# MONITORING YEAR 4 ANNUAL REPORT

## HENRY FORK MITIGATION SITE

Catawba County, NC  
DEQ Contract No. 005782  
DMS Project No. 96306

RE: **Response to MY4 Draft Report Comments  
Henry Fork Mitigation Project**  
DMS Project # 96306  
Contract Number 005782  
RFP Number 16-005298  
Catawba River Basin – CU# 03050103 Expanded Service Area  
Catawba County, North Carolina

### Groundwater Gage Plots

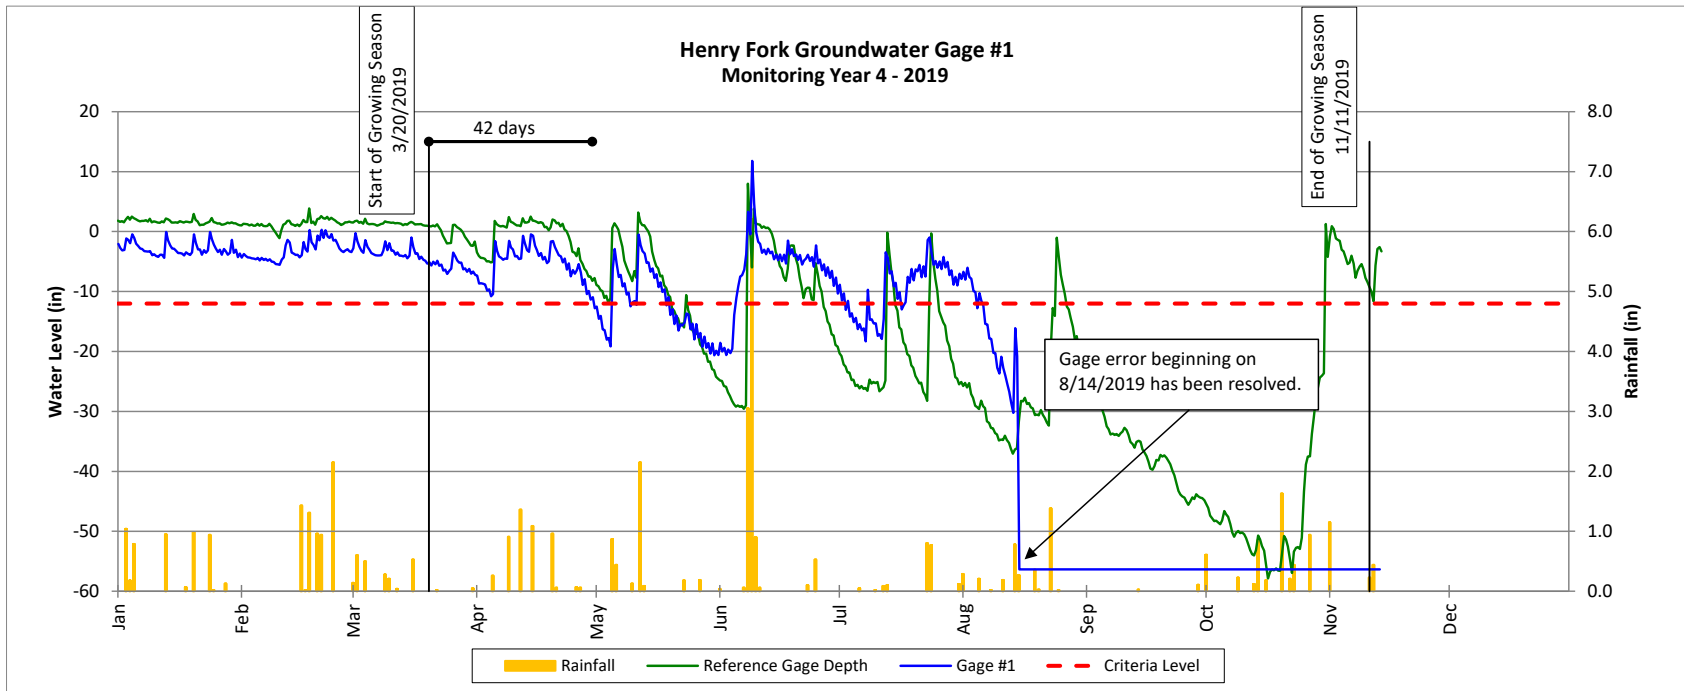
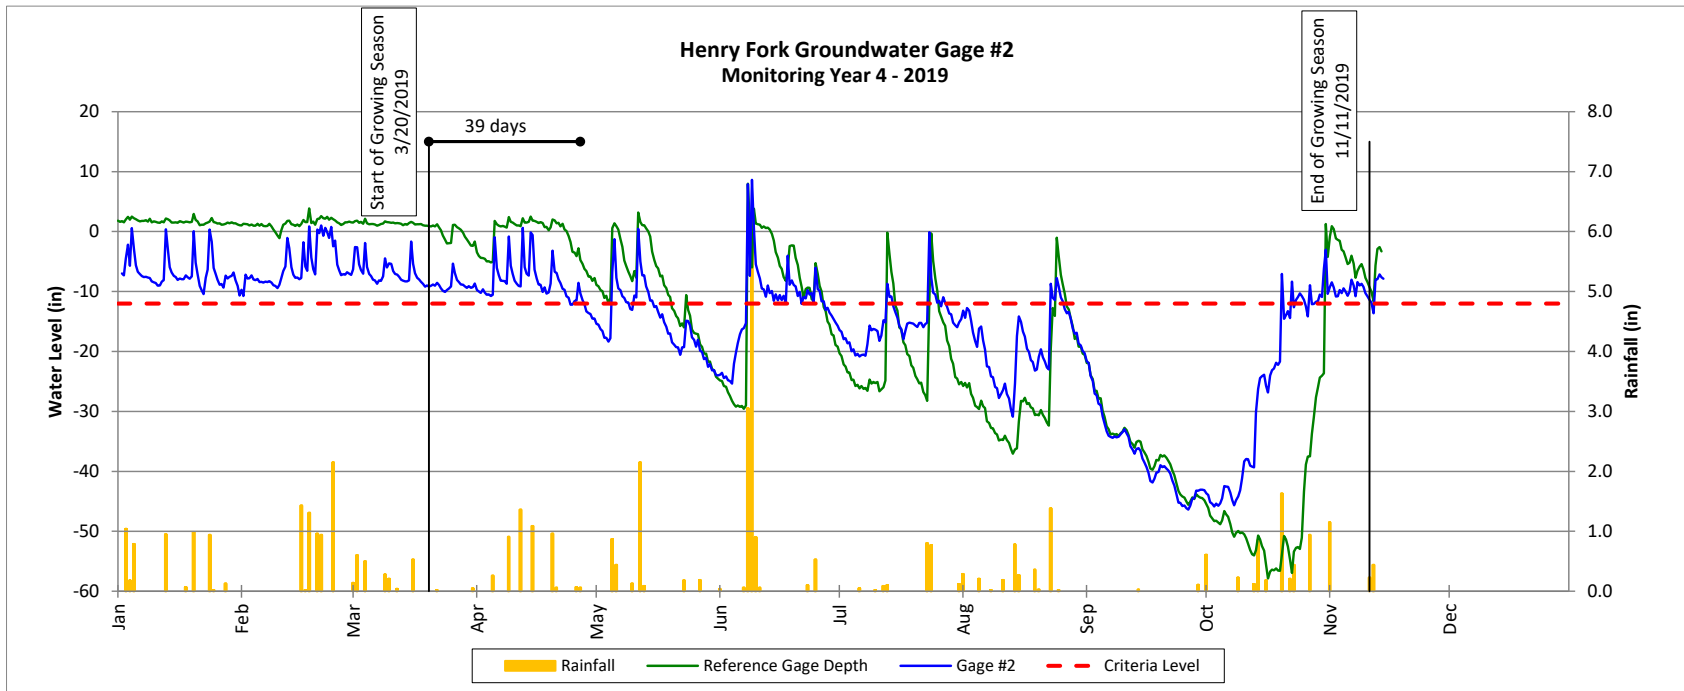
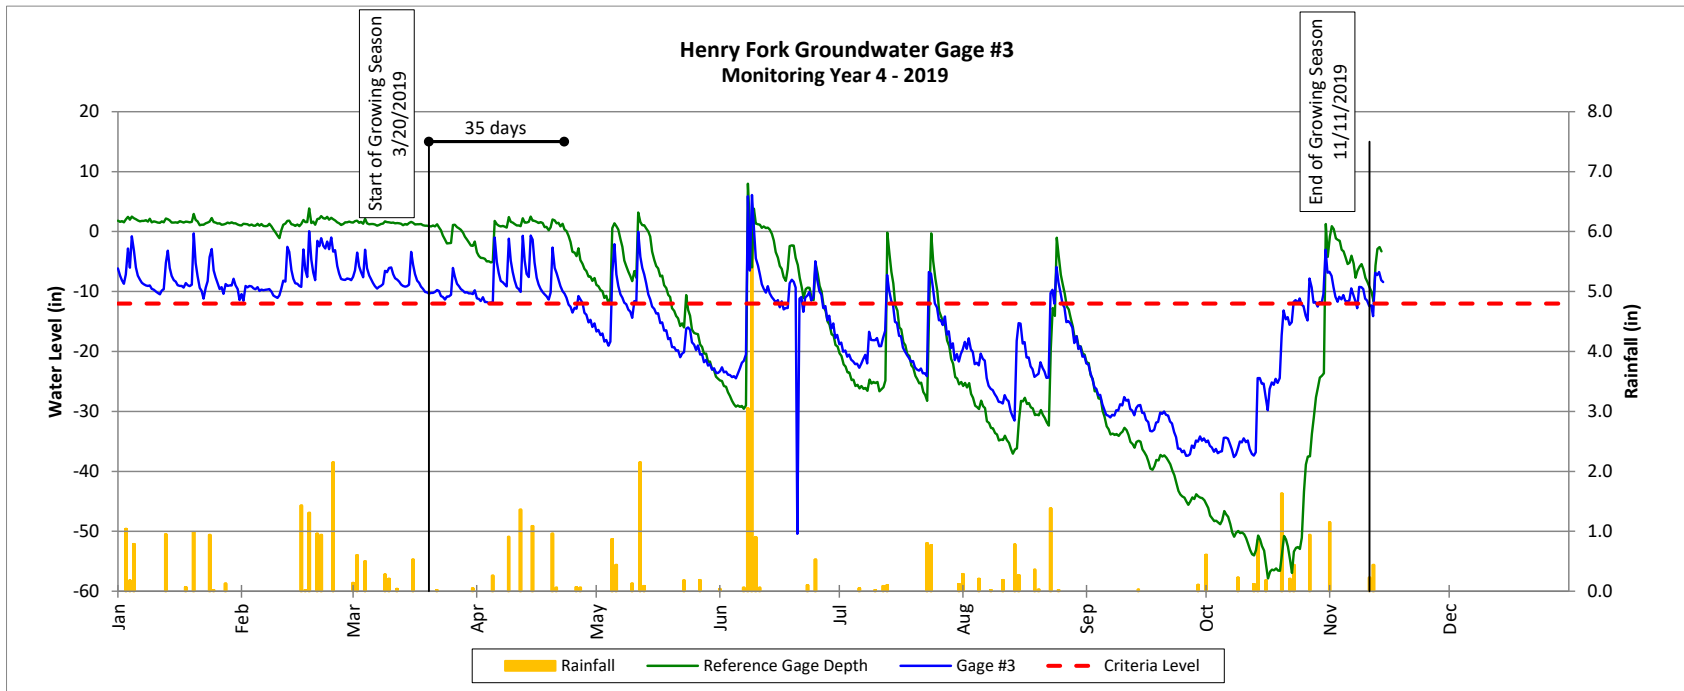
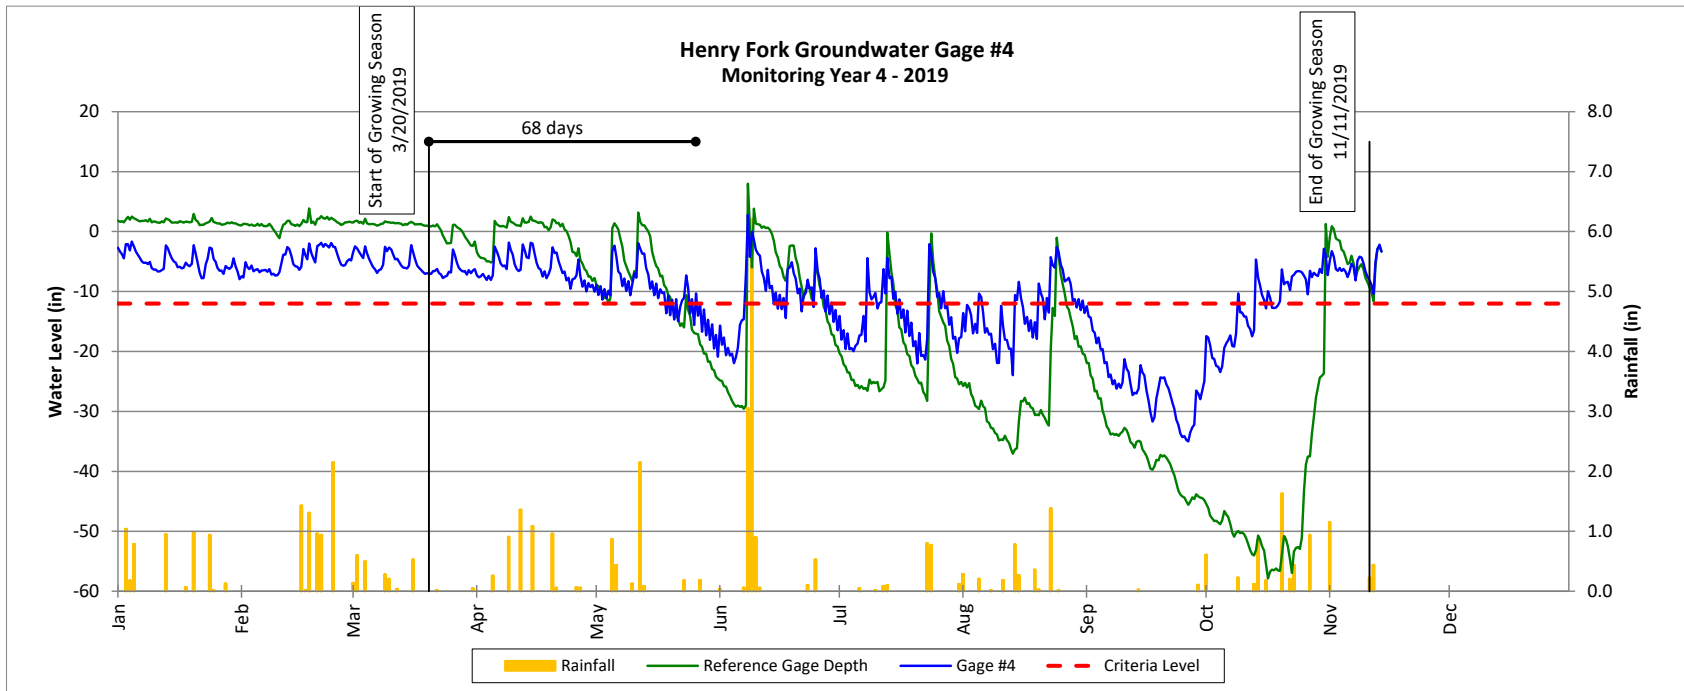
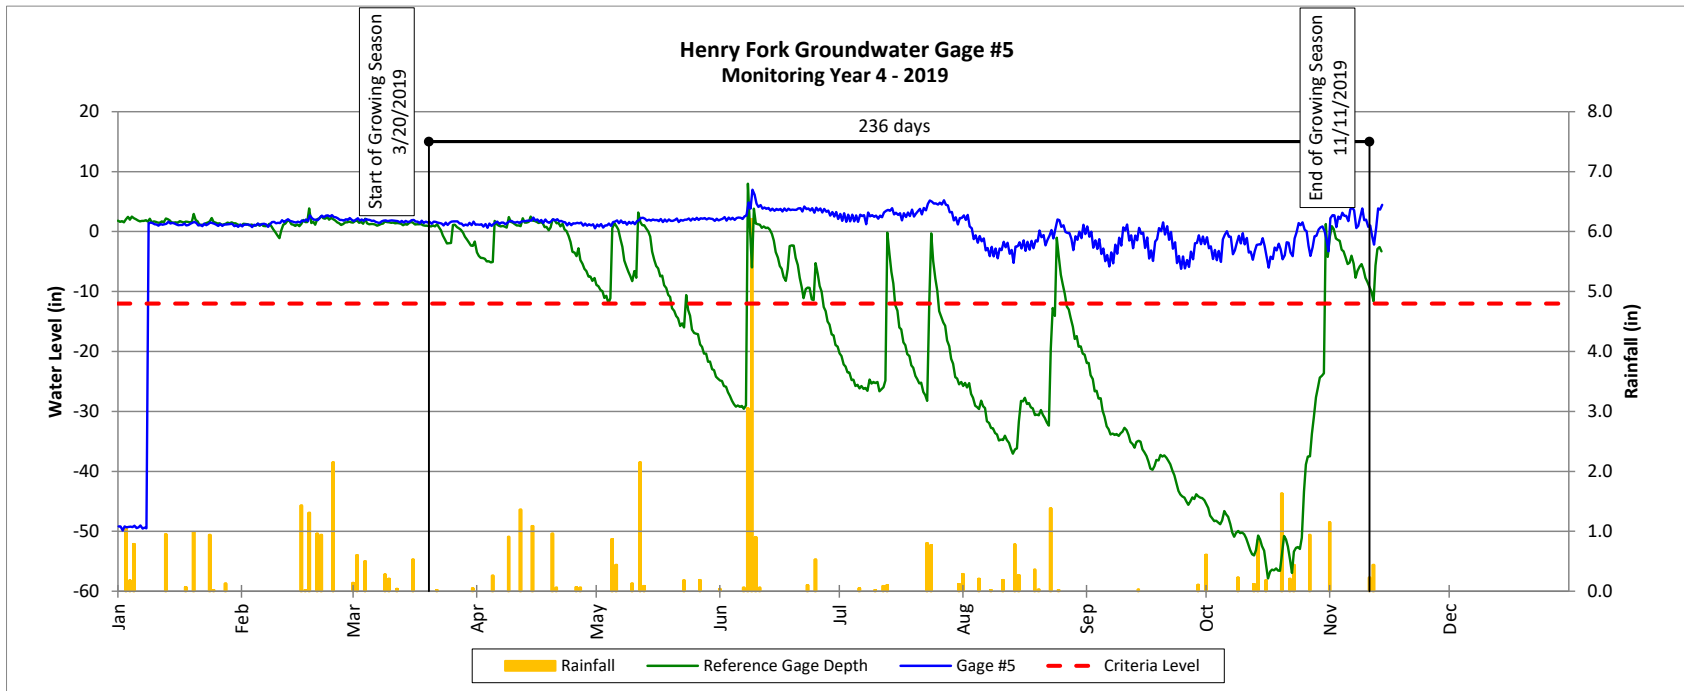
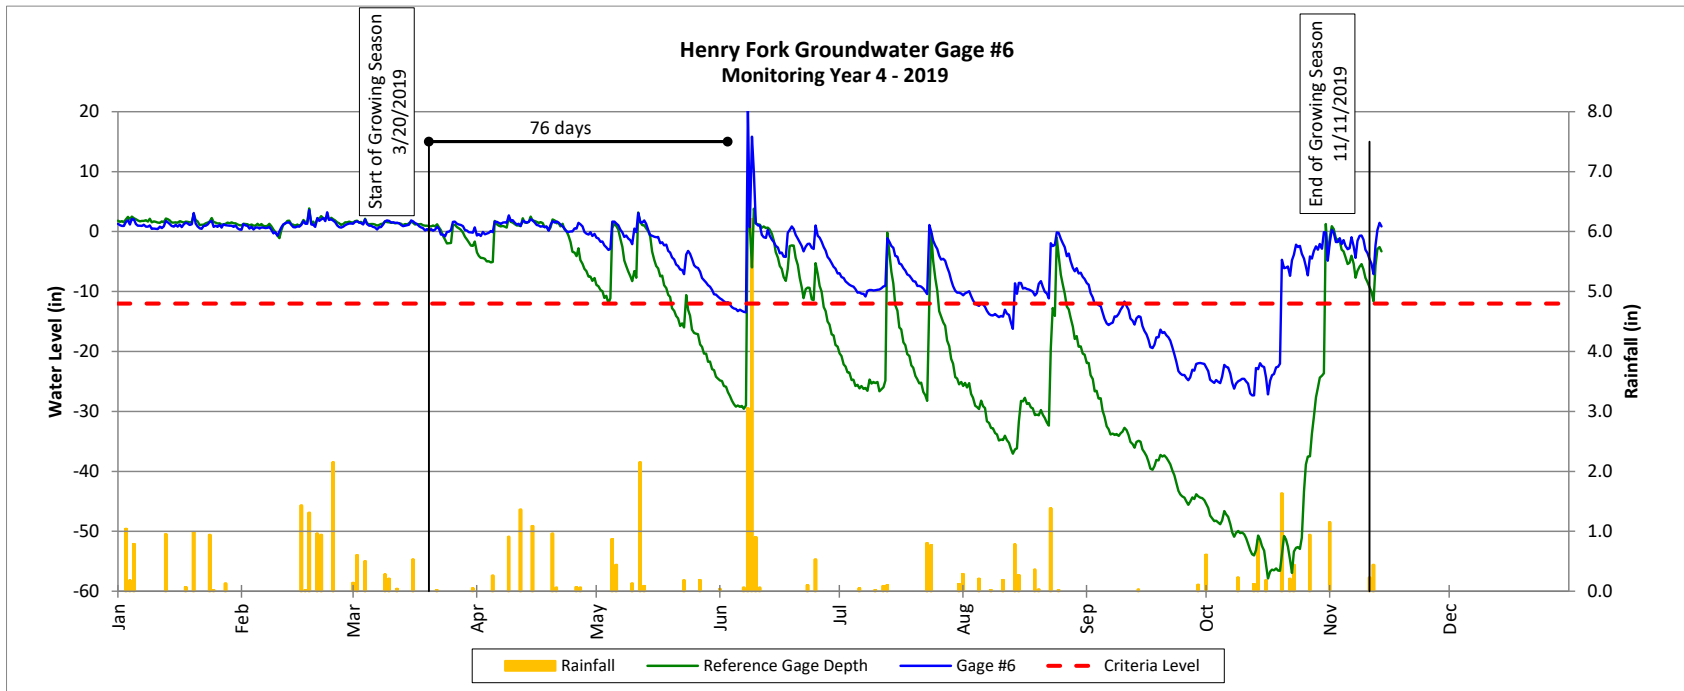
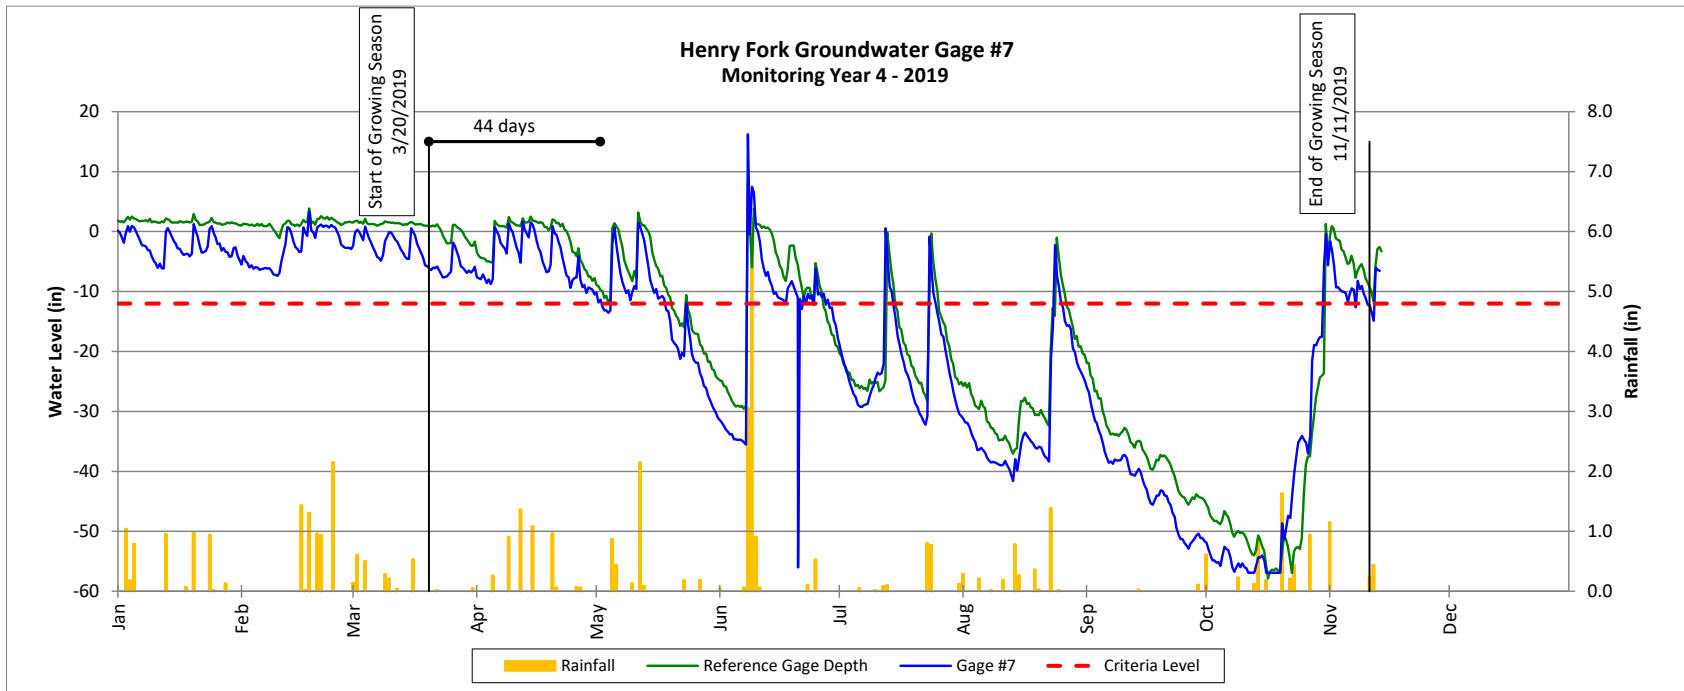
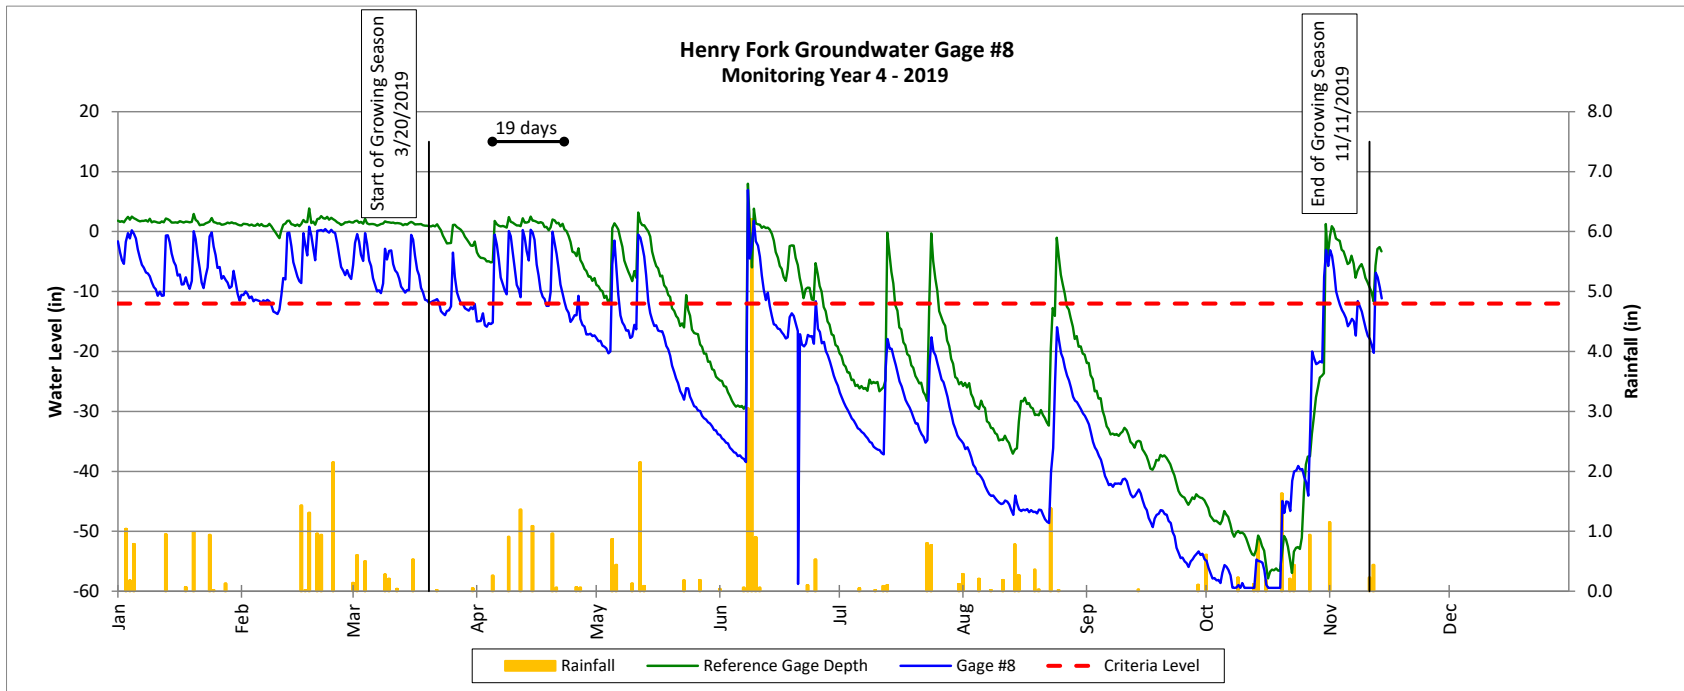
**DMS comment; For clarity, consider adding the consecutive day number for each gage on the groundwater gage plots instead of using the currently shown 20 day bar. The gage 8 plot shows 19 days which corresponds to the consecutive days for that gage. All the other gages use the 20 day bar.**

**The 20 day bar adds some confusion to the plots without a description of what it corresponds too (8.5% of the growing season).**

*Wildlands response; For clarity, the number of consecutive days is now shown instead of the 20 day bar on all groundwater gage plots.*
